**Town of Davidson
Design Review Board Regular Meeting
Town Hall and Community Center
Community Room 120
251 South Street
Wednesday, August 21, 2024 at 5:30 PM**

DESIGN REVIEW BOARD: STAFF REPORT

Date: August 21, 2024
To: Design Review Board
From: Lindsay Laird, Senior Planner
Re: Sadler Square – For approval of building schematic design

Date: August 21, 2024
To: Design Review Board
From: Lindsay Laird, Senior Planner
Re: 201 South Street – For approval of building schematic design

Figure 8. Sketch of Decorative Element at Griffith Street Corner

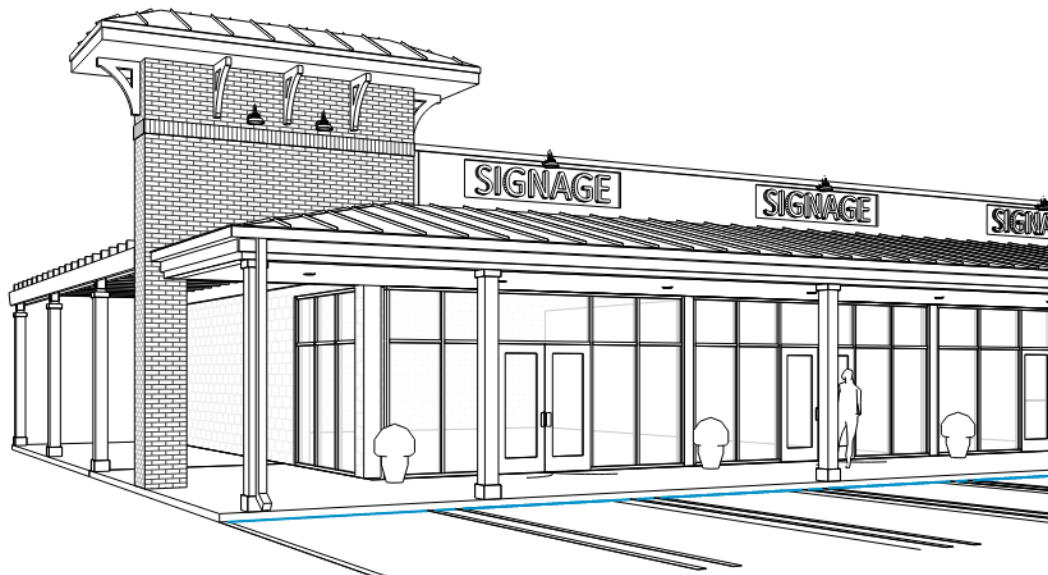
- An architectural element that emphasizes/anchors the building corner on Griffith Street so that it creates a more balanced façade composition.
- At the corner element, increase the roof overhang and/or decrease the size of brackets.

Plans were updated to include a decorative element at the end of the façade facing Griffith Street.

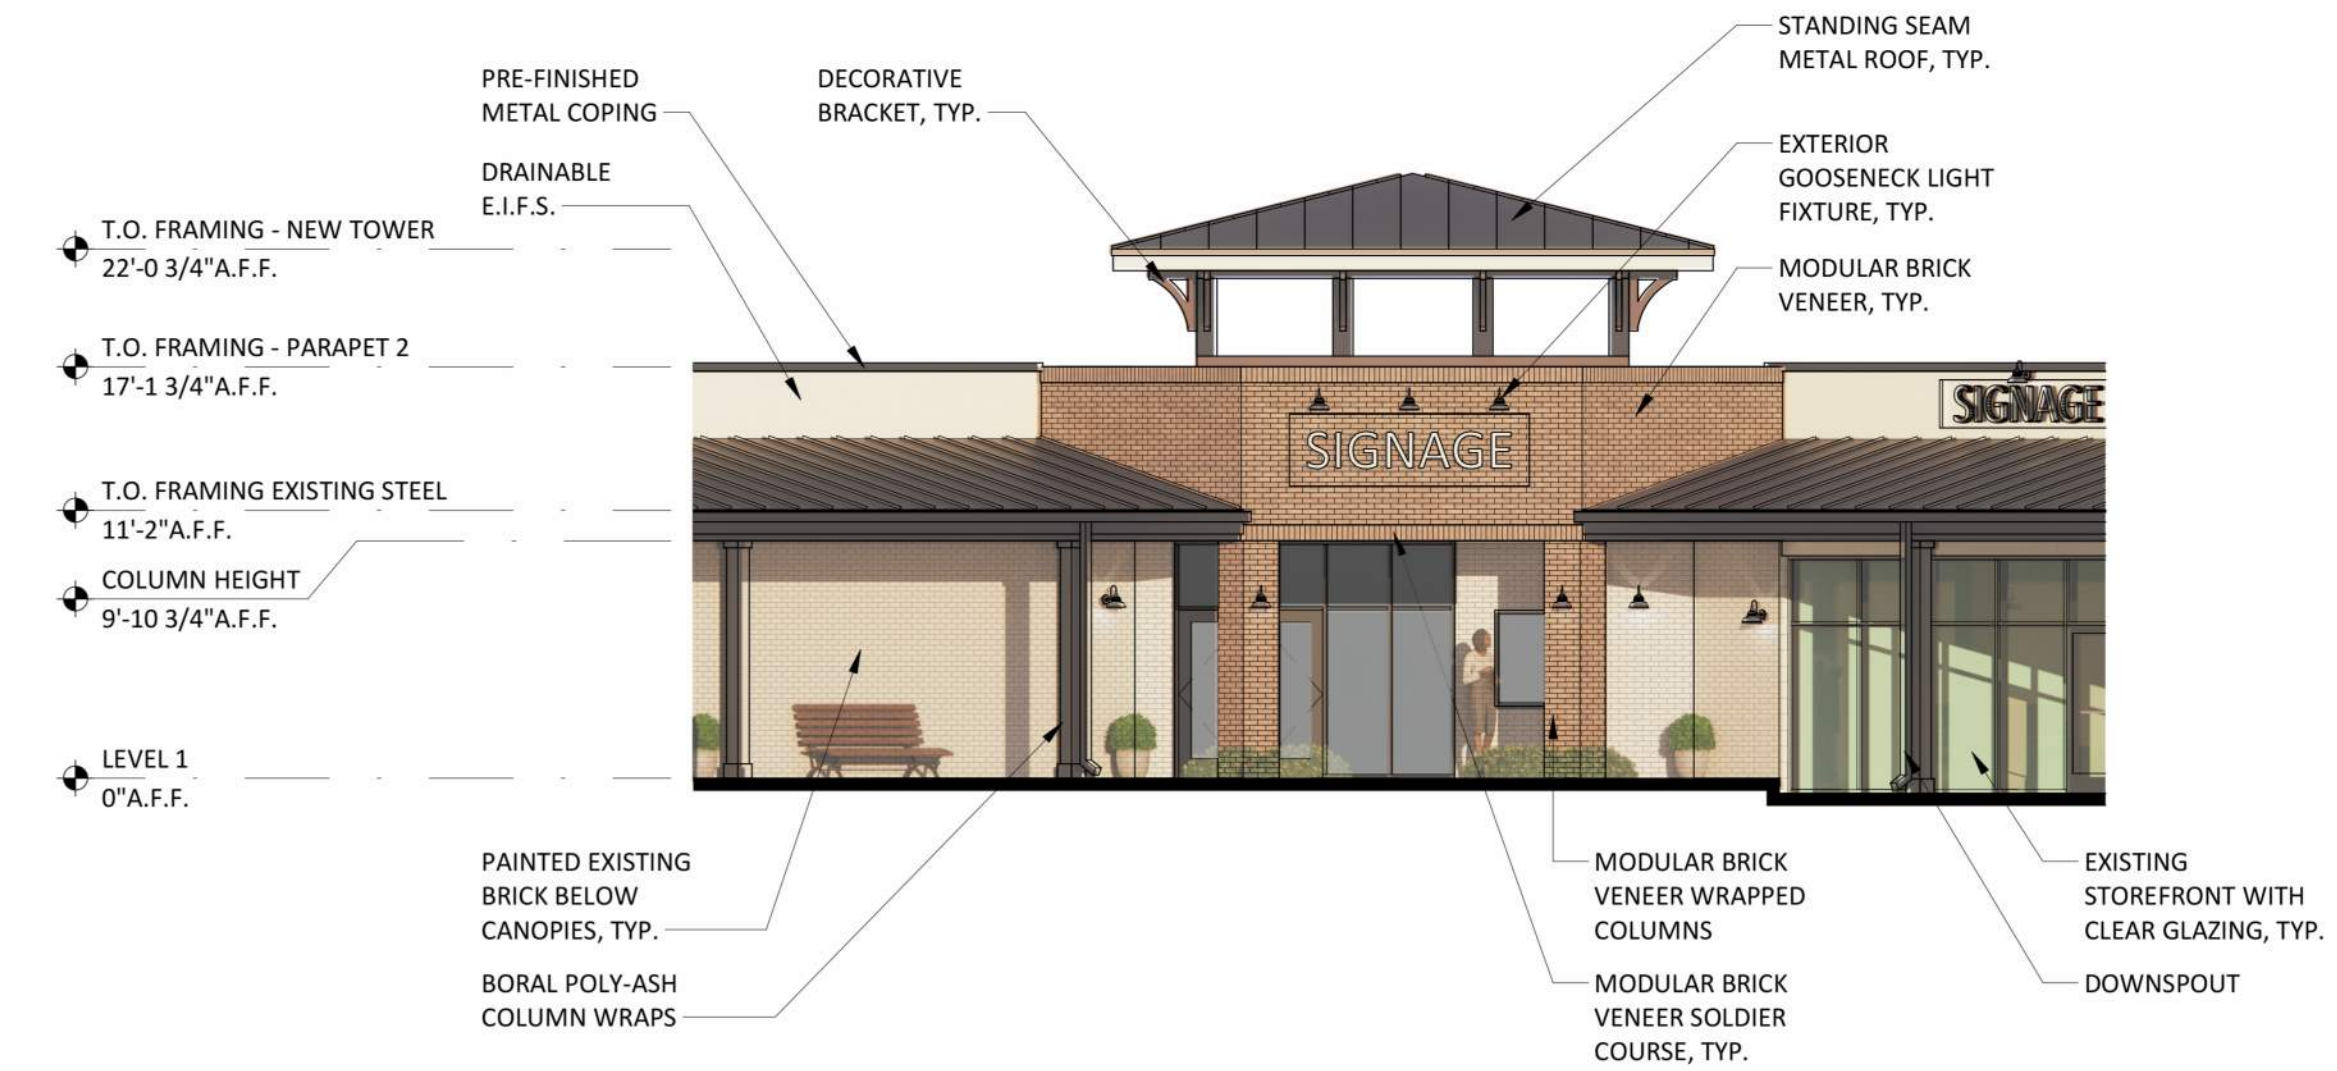
- **4.4.1.F Architectural Details:** Architectural elements like openings, sills, bulkheads, columns, and other architectural features shall be used to establish human scale at the street level.
Review canopies/columns and the corner element at the existing entrance to Our Town Cinemas. Do these elements help to establish human scale?

Figure 12. Current First-floor Plan w/ Trash & Mechanical Units Shown

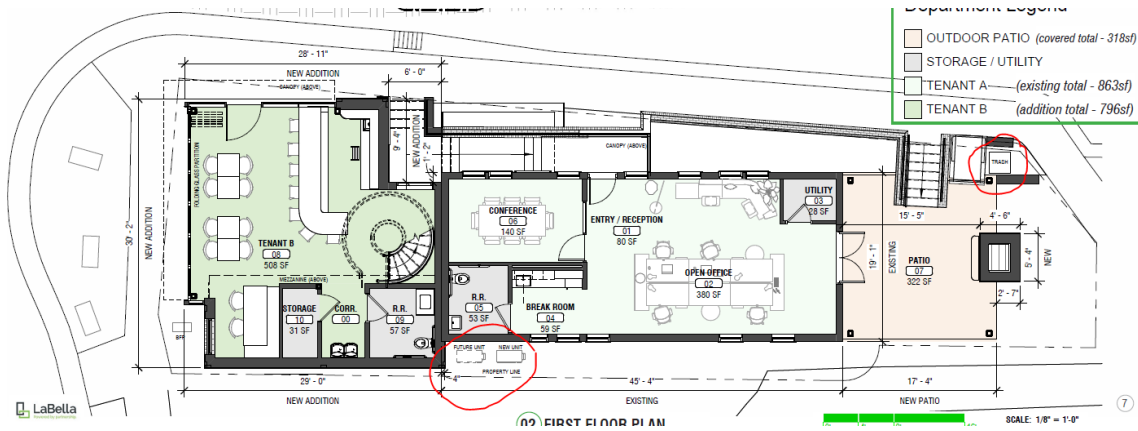
- Materiality above the glazing on the addition.
- Provide more information regarding site logistics in terms of trash/waste removal, mechanical units (HVAC), and associated screening.
- Explore brick options.

Trash and mechanical units are now called out on the first-floor plan (Sheet 7 of plan set).
